Stage 1-2 Road Safety Audit

Bury Old Road, Manchester

Unimore Limited

5 March 2025

Drawing No. ST21343-102-P0 - S278 Signing Lining and Kerbing Plan-A1L

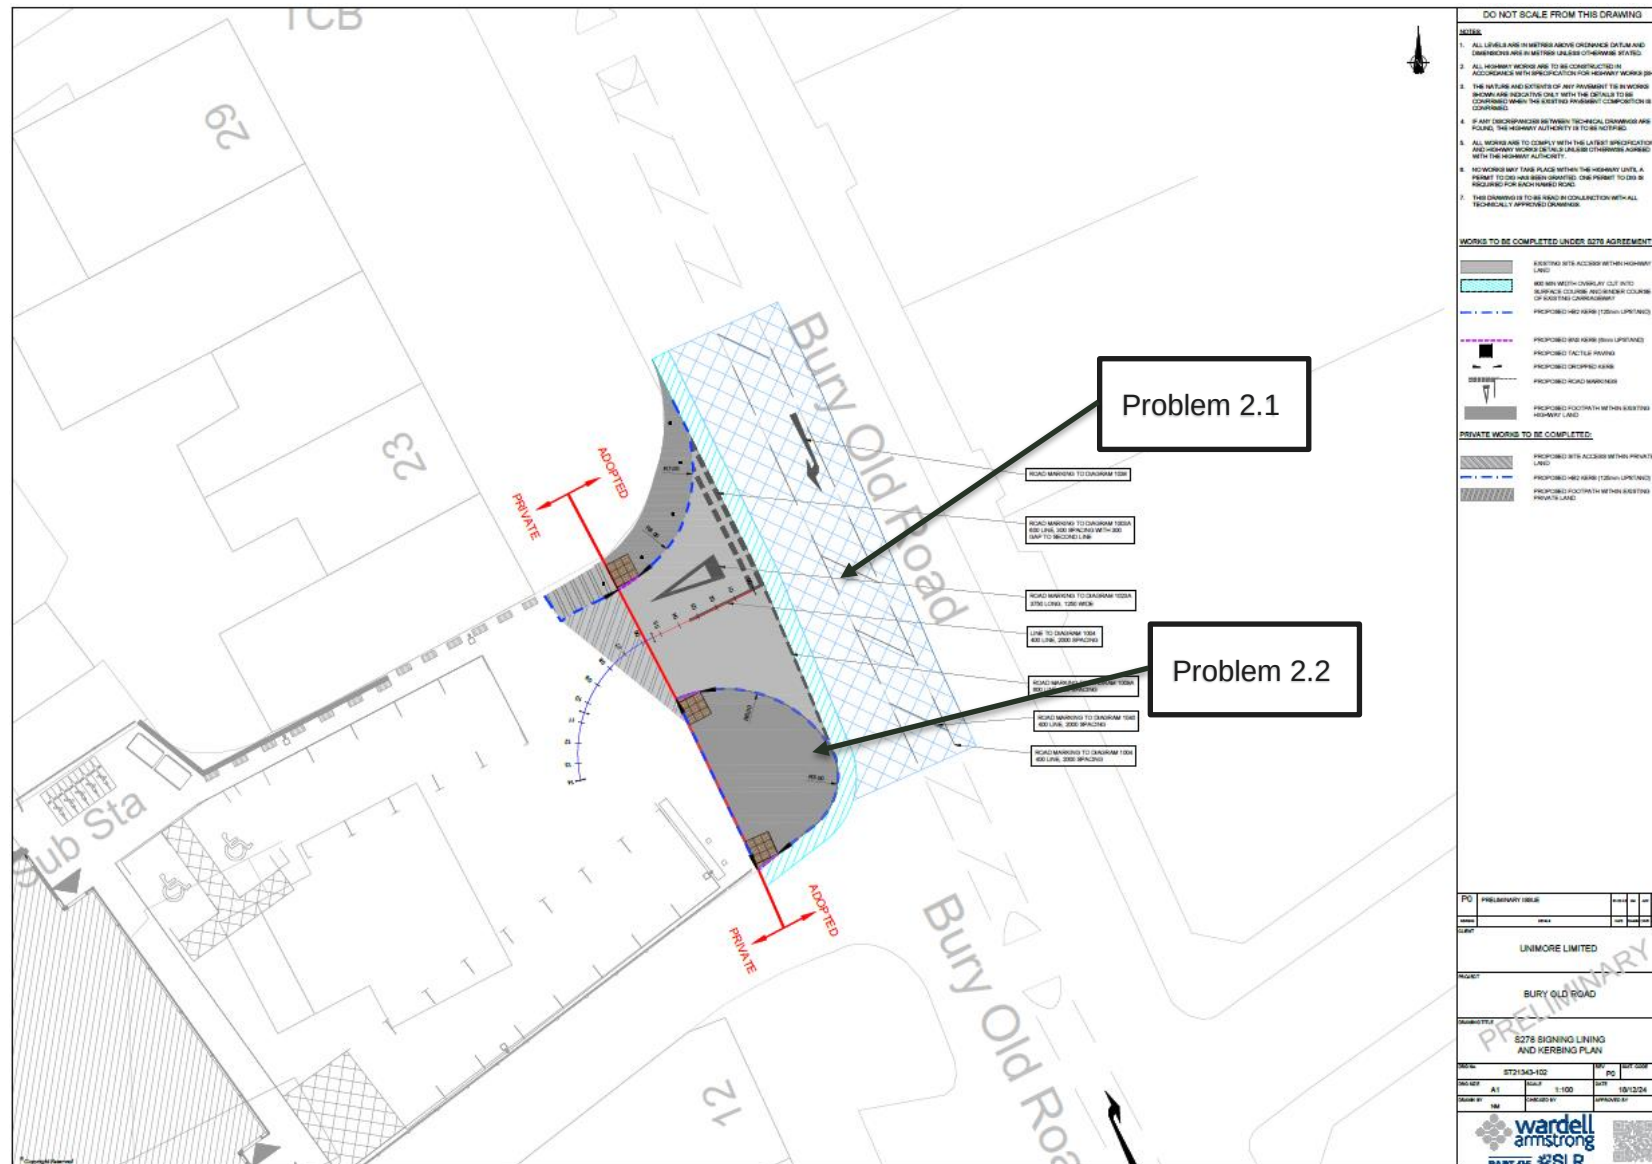
Location: Ghost island right turn facility.

Summary: Road marking may lead to overrun of opposing lane on the minor arm potentially causing head on collisions.

Design drawings show road markings for the ghost island right turn appear to terminate the right turn in alignment with the egressing lane on the minor arm. This arrangement may lead to drivers accessing the site, turning too early and overrunning the egress lane of the site junction potentially leading to head on type collisions between vehicles.

Location: Amended traffic island / footway.

Summary: Lack of bollards to prohibit vehicular access may lead to injudicious parking potentially obscuring visibility splay causing side swipe type collisions.

Design drawings do not show any parking prevention measures that are found on junctions surrounding the site access junction. Failure to provide these bollards on the amended traffic island may lead to injudicious parking as was observed during the site visit. This arrangement may in turn lead to the obscuring of the junction visibility splays, potentially causing side swipe type collisions at the junction.

It is recommended that the termination marking for the ghost island right turn be removed to encourage drivers to adopt the correct position in the right turn lane prior to accessing the site.

It is recommended that the appropriate bollards / parking prevention measures are provided on the newly amended traffic island / footway to the south of the site access junction.

Drawing No. ST21343-104-P0 - Swept Path Analysis and Visibility Splays-A1L (2)

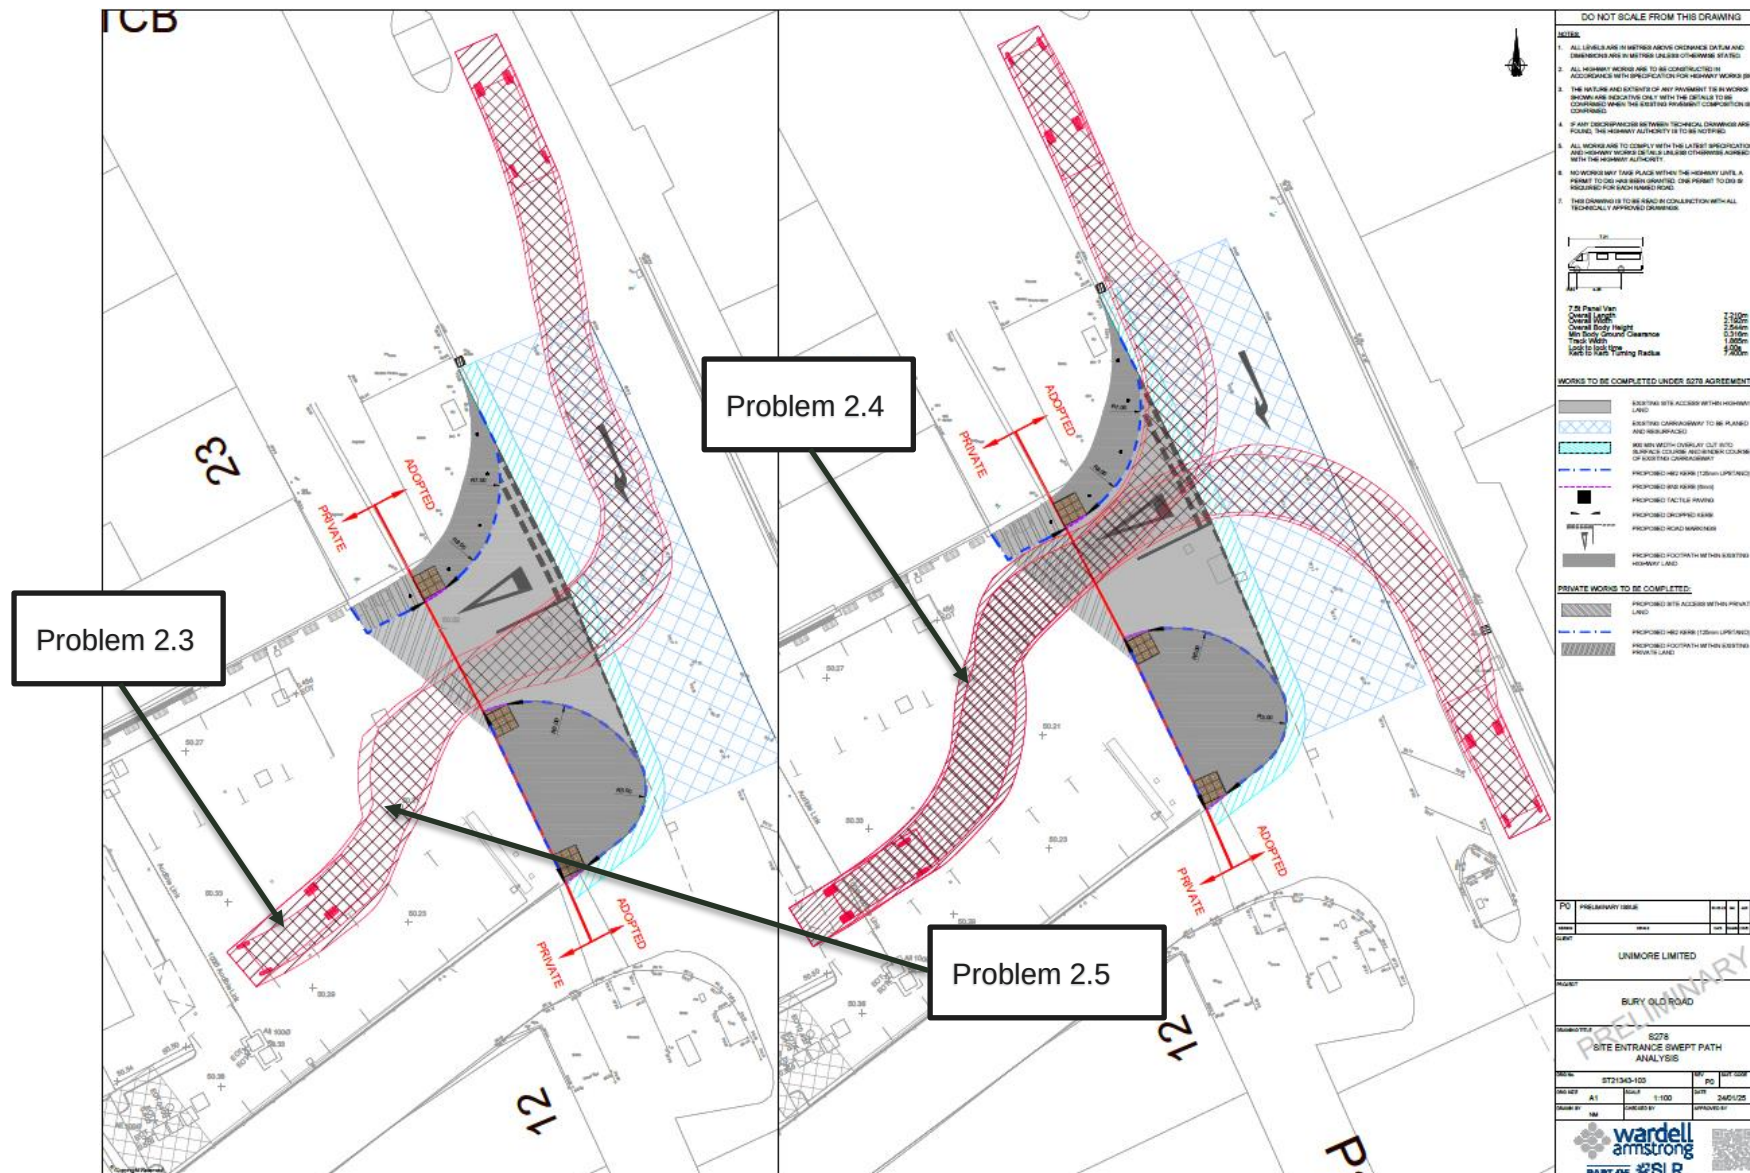
Location: Internal servicing area.

Summary: Lack of turning area for servicing vehicles may lead to shunt type collisions or collisions between pedestrians and vehicular traffic.

Design drawings do not show an appropriate turning facility for service vehicles. This arrangement may lead to large delivery vehicles reversing back out of the site onto the public highway potentially leading to shunt type collisions, or collisions between reversing vehicles and pedestrians accessing or passing the site access junction.

Location: Internal servicing area.

Summary: Swept path of an egressing vehicle is shown to overrun parking bays which may lead to collisions between vehicles.

Design drawings show the swept path analysis of a service vehicle egressing the site and overrunning a parking bay. This arrangement may lead to collisions between servicing vehicles and those private vehicles either parked or within the process of accessing or egressing the site.

Location: Car park area.

Summary: No swept paths for car parking and the aisle space between the bays does not look sufficient to allow easy reversing out of a space, which may result in cars reversing out onto the public highway potentially leading to shunt type collisions, or collisions between reversing vehicles and pedestrians accessing or passing the site access junction.

It is recommended that the appropriate measures be undertaken to ensure that service vehicles are not required to overrun parking bays in order to access / egress the site in a forward gear. Or that servicing is undertaken out of hours when the car park is not in use.

It is recommended that the appropriate measures be undertaken to ensure that service vehicles are not required to overrun parking bays in order to access / egress the site in a forward gear. Or that servicing is undertaken out of hours when the car park is not in use.

It is recommended that the appropriate measures be undertaken to ensure that adequate space is provide in the aisle between the bays to enable safe manoeuvring of cars in and out of the designated parking bays. Swept path analysis also needs to be provided.
